Our ref: 10.121.046.

**Dendrobium Mine Extension Project- Environmental Impact Statement  
Areas 5 & 6**

Figure 4.4 of the MSEC856 report reproduced below shows horizontal movement plotted against distance from active longwall. Given the extreme consequence of the dams it is appropriate to use the 99% confidence level to predict movement at the dam wall for a set distance from the longwall goaf.

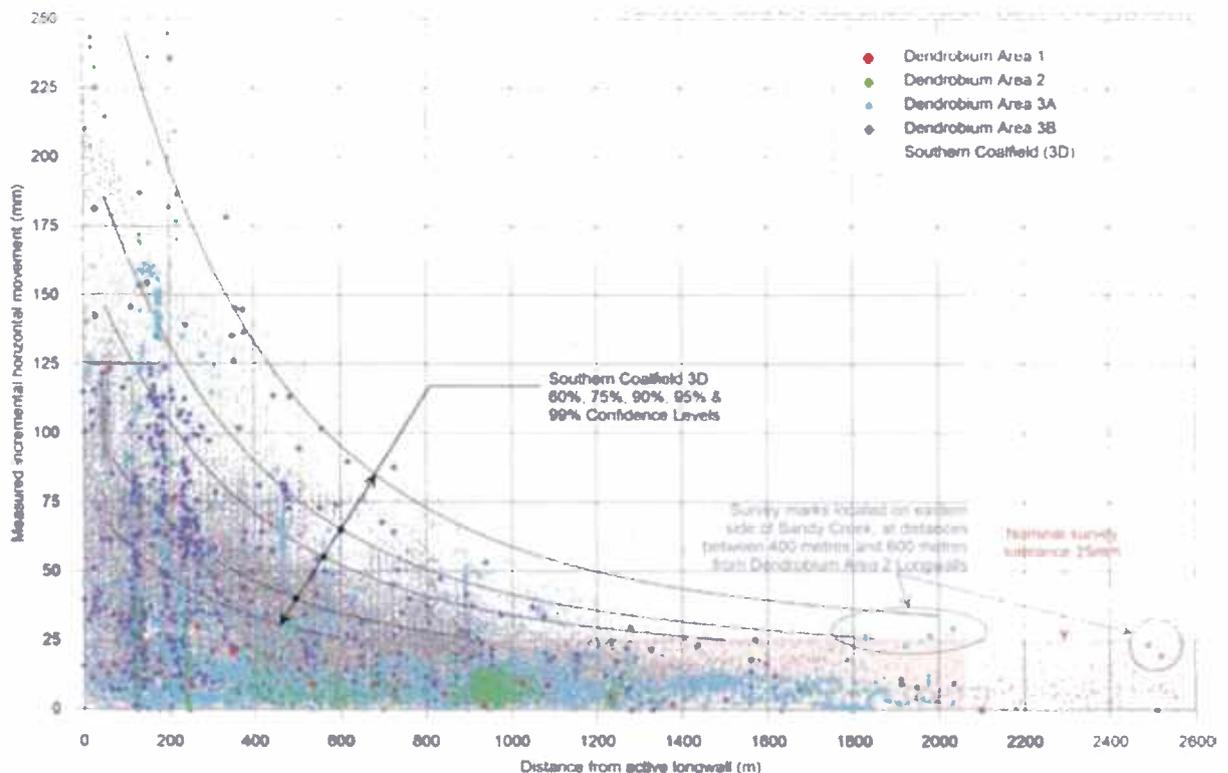
These large structures with extreme consequence categories are sensitive to differential movement, but the subject has not been addressed by the report.

As the long axis for both dams are aligned with the long axis of the longwalls there is differential movement between the left and right abutments of the dam walls.

For Avon Dam with a crest length of 223m at 1000m from Area 5 longwalls, the chart above predicts the right abutment moves 10mm more towards the goaf than the left abutment.

For Cordeaux Dam with a crest length of 405m at 1000m from Area 6 longwalls, the chart above predicts the right abutment moves 16mm more towards the goaf than the left abutment.

The differential movement on the dam walls could cause cracks to open in the dam walls.

**To reduce the likelihood of cracking the dam walls, longwall extraction should approach no closer than 1,500m to the dam walls.**

**An assessment by an appropriately qualified Dams Engineer is required to determine if the longwalls should be moved further away from the dam walls.**
